**PLANNING DIVISION REPORT
DEPARTMENT OF PLANNING AND COMMUNITY
AND ECONOMIC DEVELOPMENT
October 3, 2008**

RE: I.D. #12152, Conditional Use Permit – 637 South Shore Drive

DATE: September 15, 2008
TO: Plan Commission
FROM: Larry D. Nelson, P.E., City Engineer
SUBJECT: 637 South Shore Drive Conditional Use

Re: Additional comments regarding conditional use application for a new garage at 637 South Shore Drive

Font Elevation

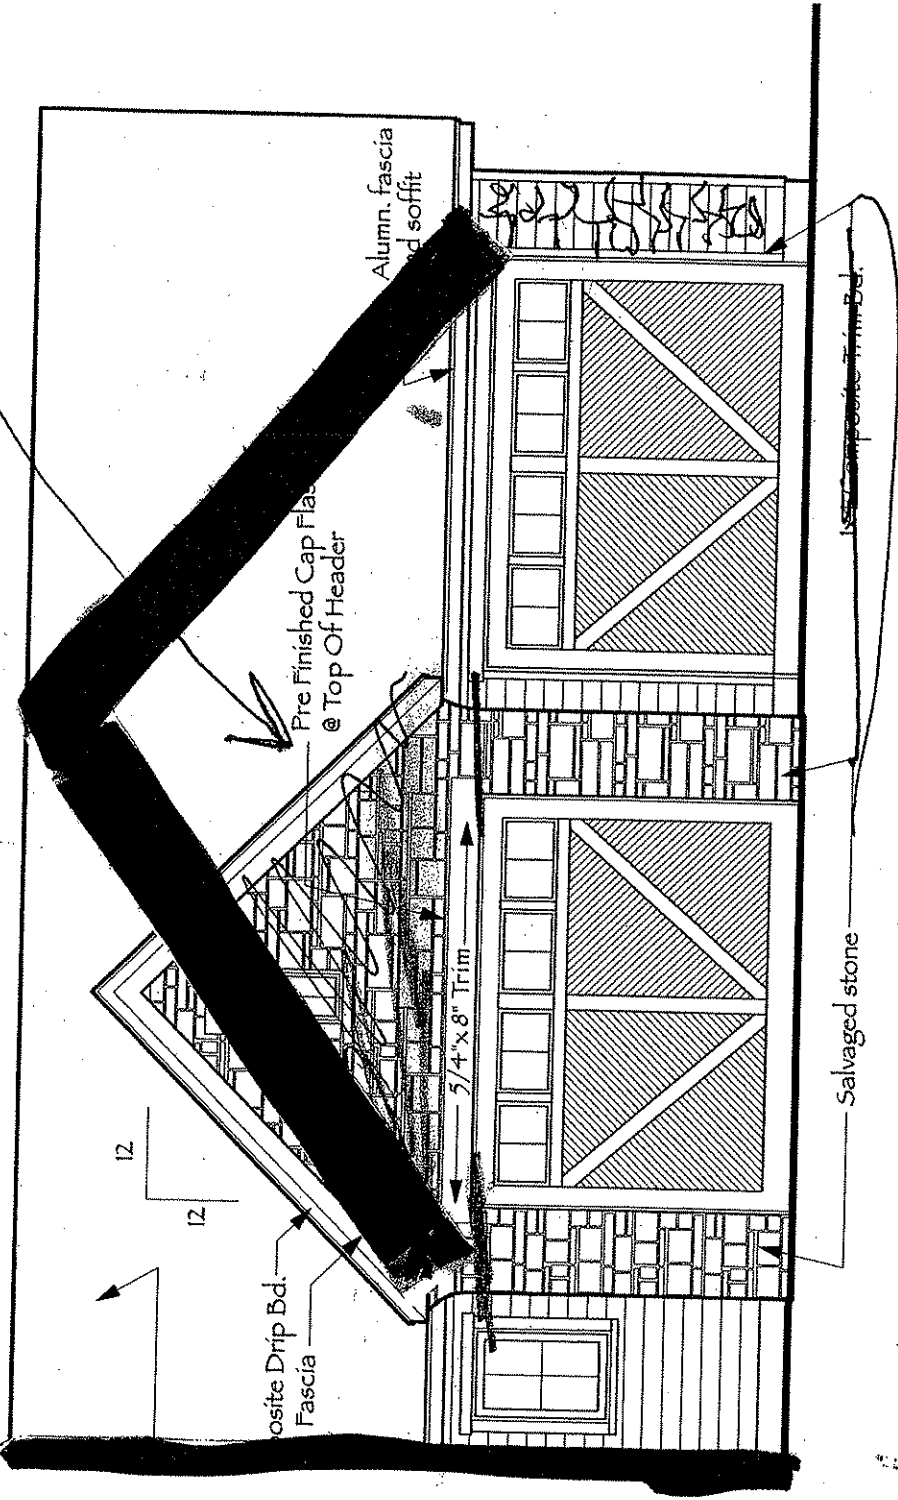
- First, an alternative design concept provided to the applicant by neighbors who were concerned that the design of the proposed garage is too fancy for the neighborhood
- Second, a letter from the architect to the neighbors responding to their concerns
- Third, a follow up letter from the applicant to neighbors responding to their concerns

Concern #1: The design does not fit the character of the neighborhood

Concern #2: The design is too fancy.

I considered the suggestion of using my initial design but cutting it off at 30' and enlarging the gable to cover both garage doors. This would be one way to make it appear closer to the Bungalow garage next to it. I have three concerns re: this idea:

■ Architecturally, it's not the best solution because the slope of the gable would require the peak to rise higher than the roof, higher than code. Otherwise the 2nd floor storage area would be so flat that one could not safely stand up in it, which would prevent one from carrying lawn furniture, etc. up into it.

Numerous houses have the Found du Lac limestone used on the Alexander home. My current design for their garage, smaller than the initial, uses more of this stone due to structural aspects of its non-symmetrical shape. There is a flow of the stone up around the garage door that is not broken by any element in the architecture. To stop it suddenly when level with the doors would suggest that they are pillars when in actuality they are not. The effect would be quite awkward and seem to just have a splash of stone just for the sake of having it.

■ The purpose of the design of the garage is to tie into and compliment the Alexander house; this design would detach it-from a visual perspective-from the house.
